Reference: FCC ID: **RCSRC1984720**

We are applying for a Class II permissive change for FCC ID: **RCSRC1984720**. The following are the changes made

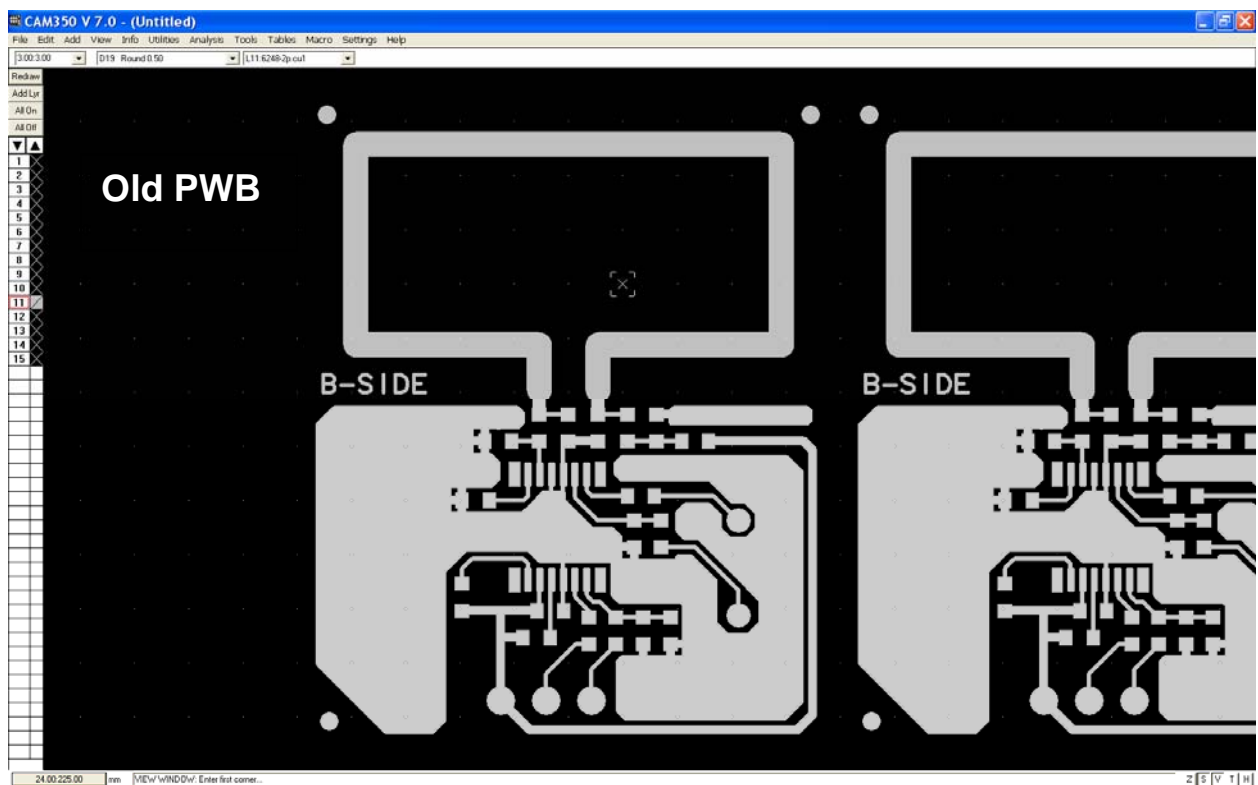
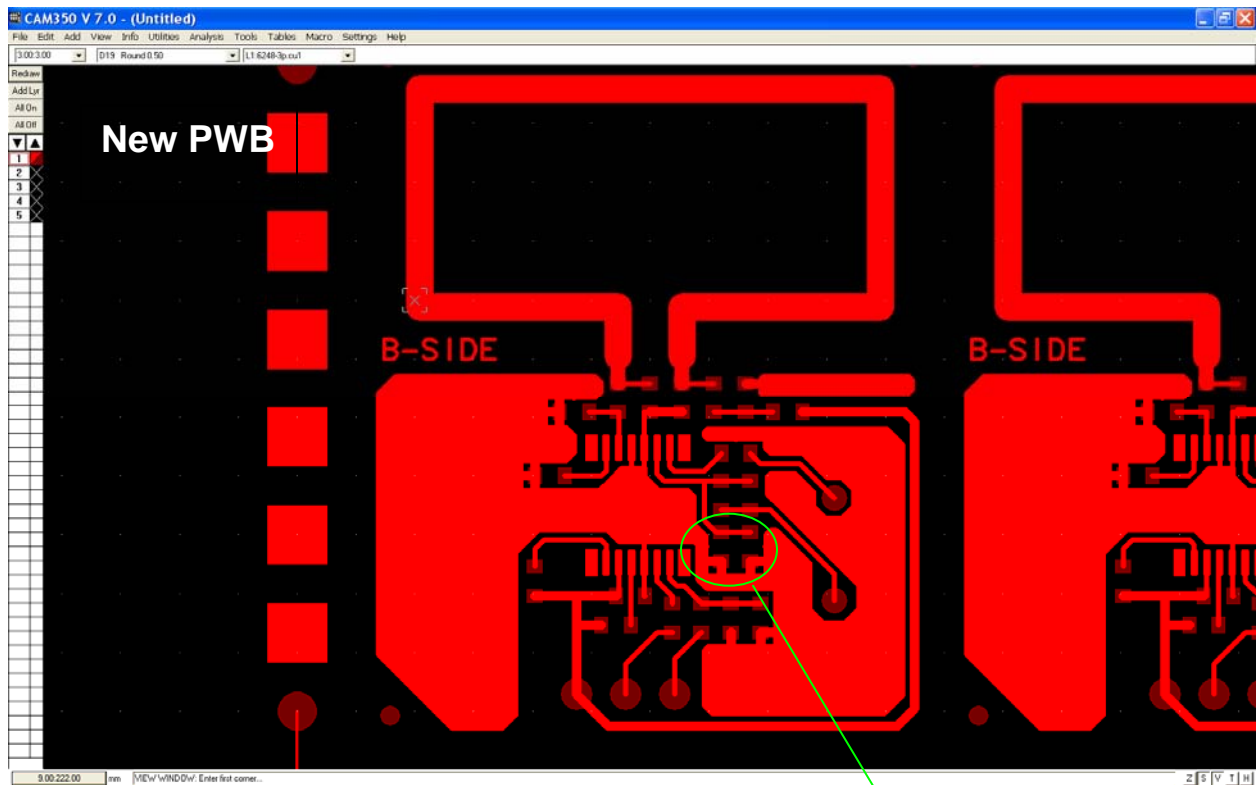
* Changes on PWB – Added Pads for additional two capacitors to improve the Frequency response of the RF transmitter (to centralize the carrier frequency & preventing it from drifting too much from set to set).

Two Pad added for two capacitor , to improve the Frequency stability
